New "NextGen" Seat Flip Operation SERVICE NOTICE #17-1011REVB

All "Flip" Seats Other Than SED Seat Require Tool

Figure #4

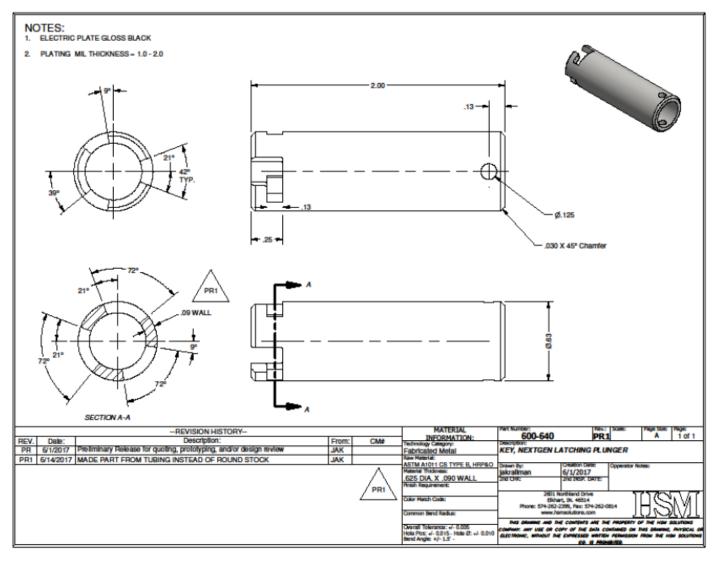
UPDATE 11-8-18 – It was brought to our attention that the warning label shown in Figure #2 is on some seats mounted at the side emergency doors. (Figure #3)

Seeing as these seats have the lock mechanism removed and a shock installed to keep the seat cushion in the raised position to maintain a clear path to the side emergency door, this warning should NOT be present. (Figure #4)

We are asking customers to check their units and remove the warning if they are present.
